Comments on applications for referral under the COVID-19 Recovery (Fast-track Consenting) Act 2020

Project name	Riverbend Road Residential Development, Napier (an application by Tawanui Developments Limited)
General comment – potential benefits	<p>Hawke's Bay Regional Council (HBRC) has a number of roles and interests in proposals for urban development within the Heretaunga Plains sub-region. These include as manager of critical flood control and drainage scheme assets, as consent authority under the RMA, as champion and advocate for the HB Regional Policy Statement and a range of other strategies including those covering urban growth, natural hazards, freshwater management, indigenous biodiversity and land transport to name a few.</p> <p>The site of the proposed development has been identified in strategic growth documents¹ as being an indicative area for future residential greenfield growth sometime during the 2015-2045 period. Nevertheless, that indicative classification does not mean any residential development on the site can proceed without further assessment and careful management.²</p> <p>The housing market in Napier and Hastings urban area is experiencing a number of chal

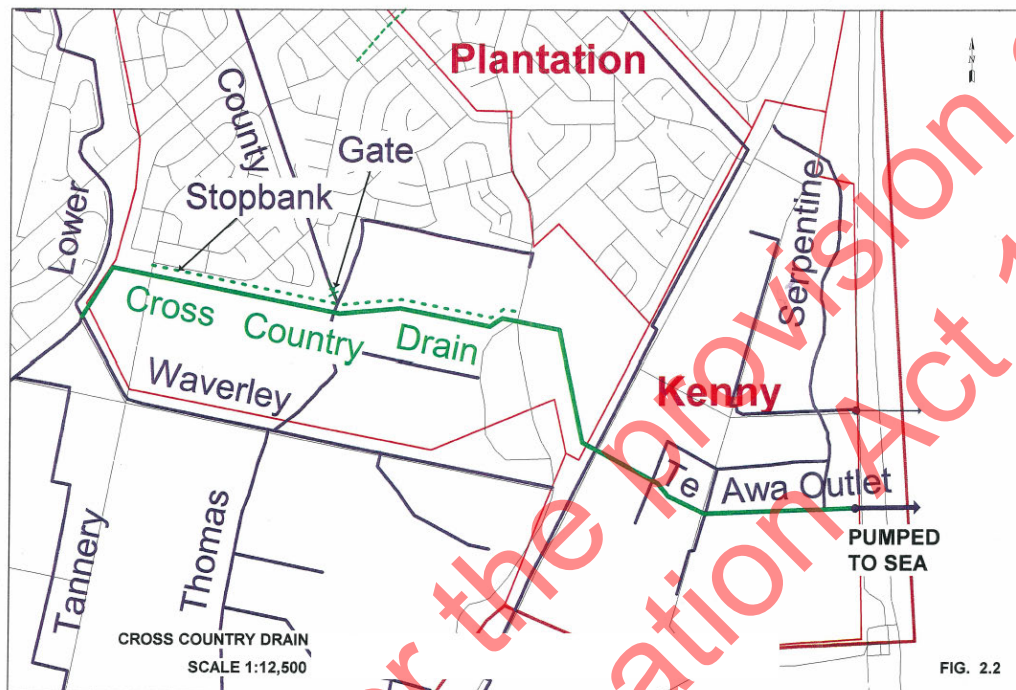
location of the wastewater pump station appears to be under a car park and/or residential building. This would not be acceptable as the land would need to be vested in the Council and would require suitable access, ventilation and working space to provide for the safety of operational staff and the public. The Council would also expect consent notices to be provided on the titles of those properties within 50m of the wastewater pump station, with regards to the operation of a wastewater pump station, noise and odour.

11. The Council recommends that emergency wastewater storage of at least 12 times dry weather flow is provided. The Council's proposed CoP will include this higher storage requirement.

Relevant Flood Hazard mapping

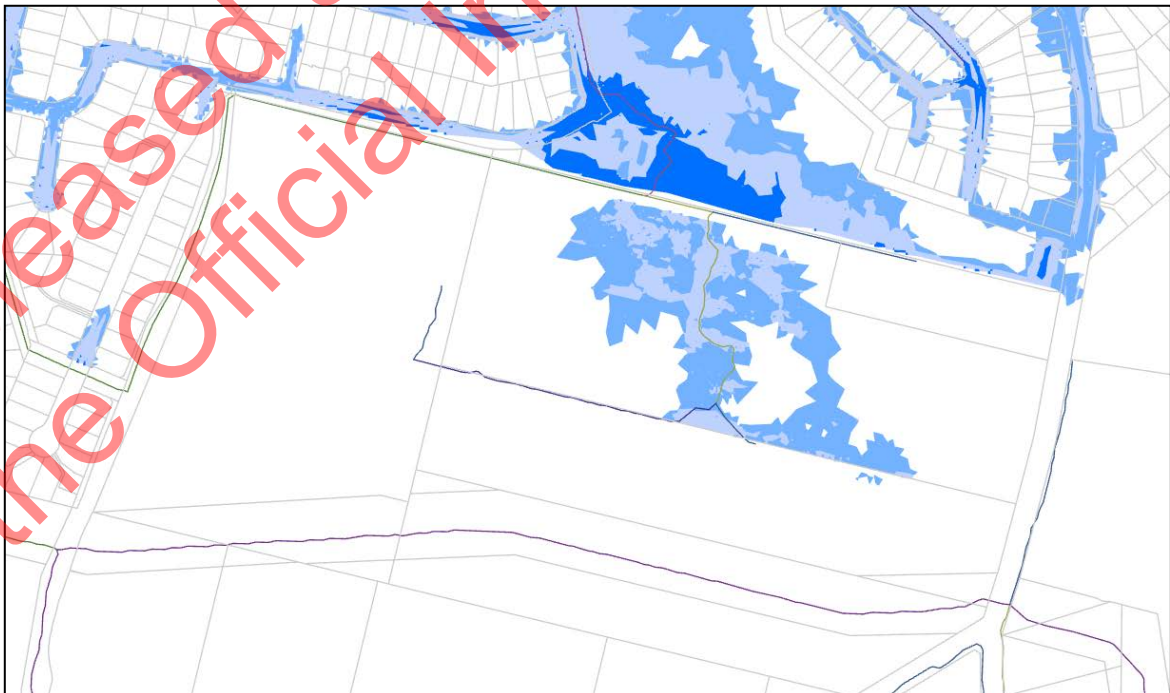
- 22. As noted above there is clear evidence of a flood hazard both from theoretical hydraulic modelling and physical, at the proposed development site.

Riverbend Road development area and Cross Country Drain – foreground.

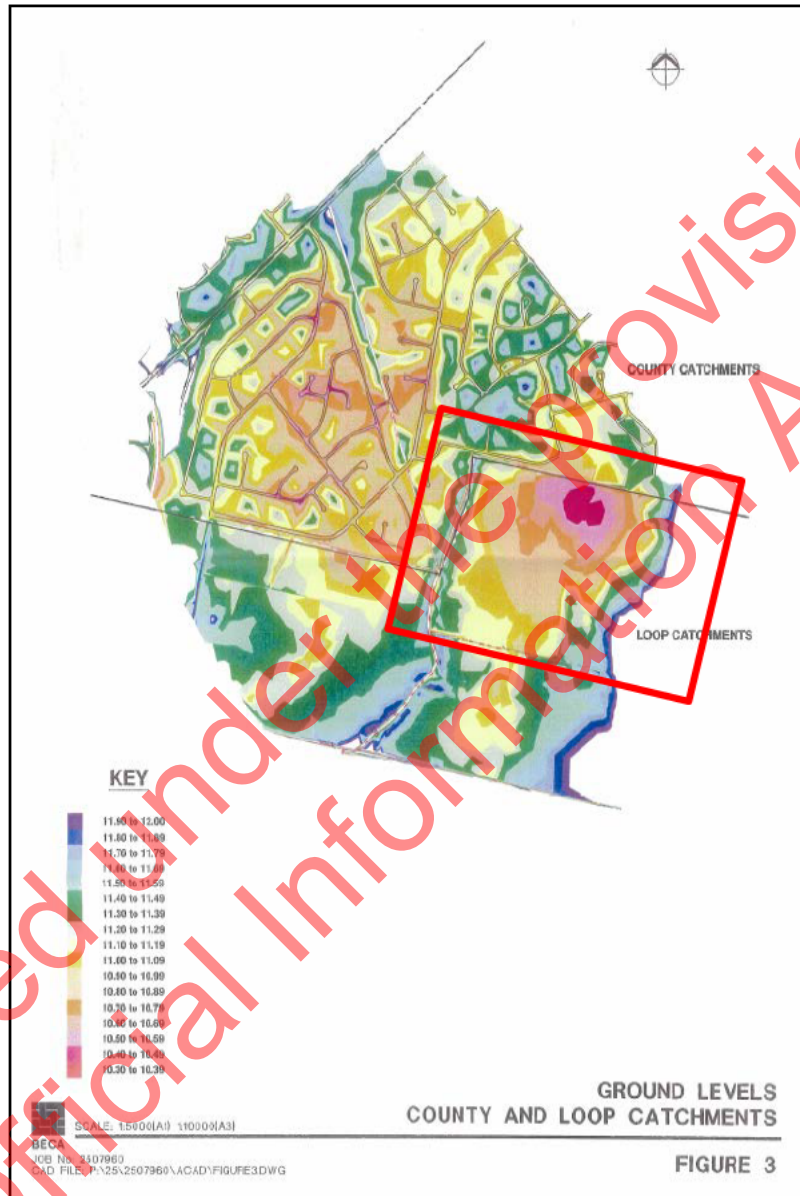
23. To achieve the finished floor levels required to protect the development from flooding, filling of the site will be required to increase the ground level. However, filling of the site will remove storage from the flood plain. The Council considers that further work will need to be done by the applicant to explain how it will provide flood storage compensation.
24. The application suggests that the development only stores flood water from the site itself, and the surrounding catchment does not contribute hence no flood storage compensation is required. However the following photographs taken on 10 November 2020, immediately after the 1 in 120 to 1 in 250 Annual Exceedance Probability rainfall event on 9 November 2020, suggest that the proposed development acts as a significant flood plain for the surrounding catchment:
